Re: Initial Submission Review – Green Valley Ranch East Site Plan No. 5 - Site Plan Amendment No. 2 Minor Site Plan Amendment and Plat

Application Number: **DA-1662-23**
Case Number(s): 2019-4022-02; 2021-3047-00

On behalf of Oakwood Homes and Terracina Design, we have reviewed the comments dated September 24, 2021. The following is a response to comments.

5 SECONDARY ENTRY GATE-PLAN VIEW (E. 51ST PL AND PICADILLY RD.)
1" = 1'

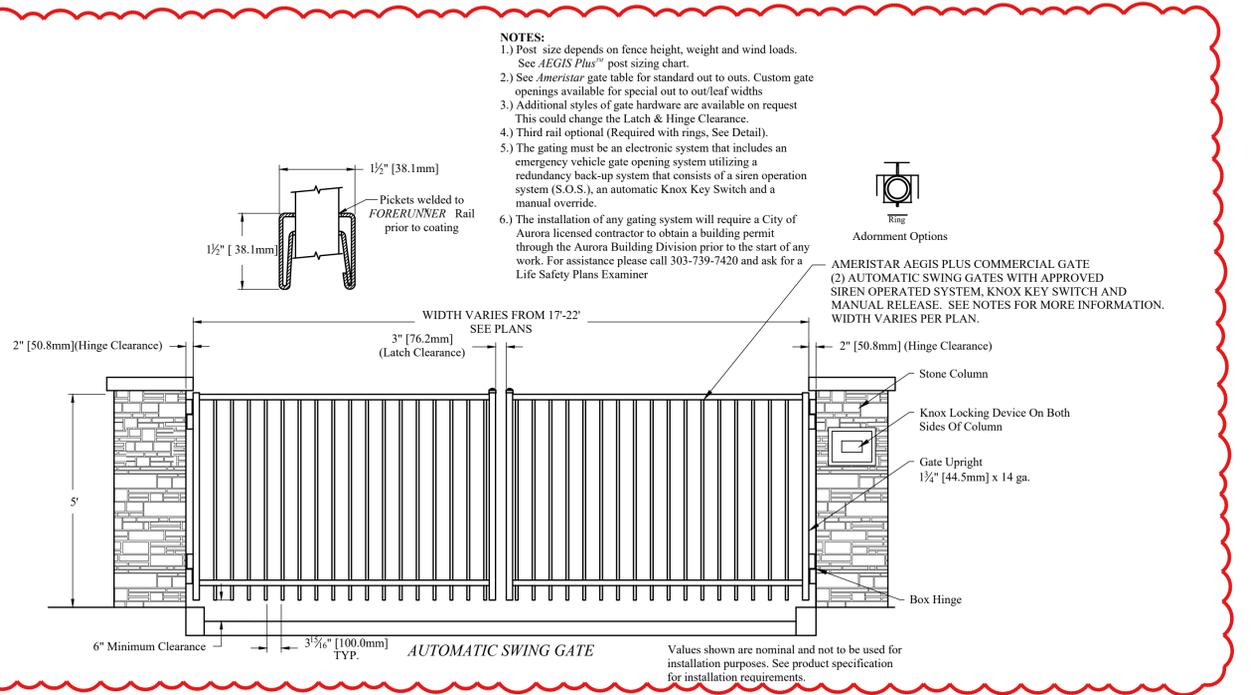
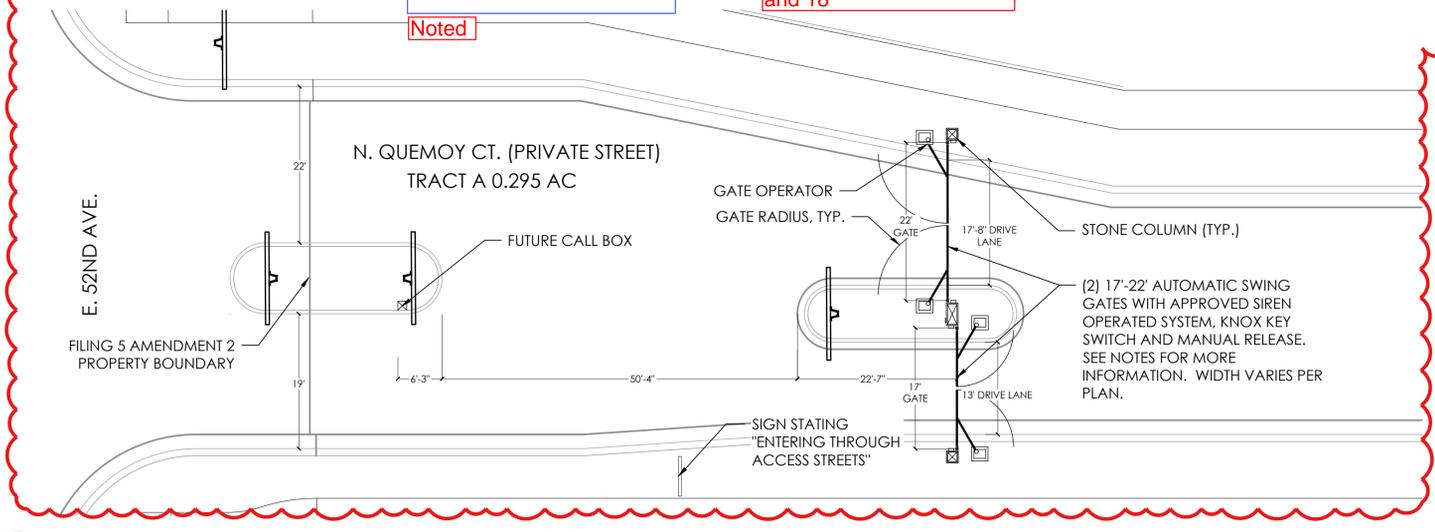
Gating systems must be reflected the site plan. Please revise the site plan to showing gating systems.

Noted
The license agreement for the gating. Please start the license agreement with Real property for the gating systems.

Gates shown on Sheet 16 and 18

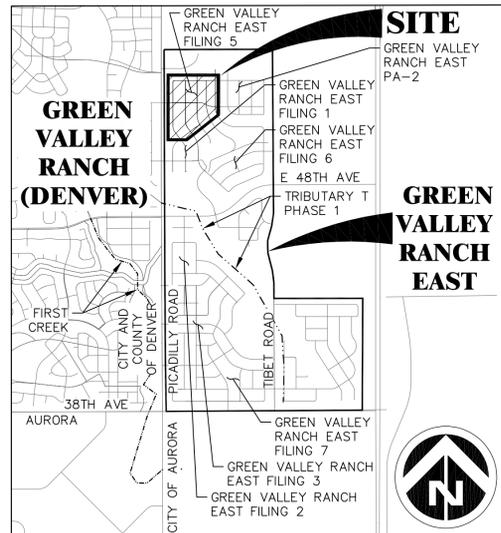
entire sheet didn't change. cloud specific items that changed.

ADDRESSED
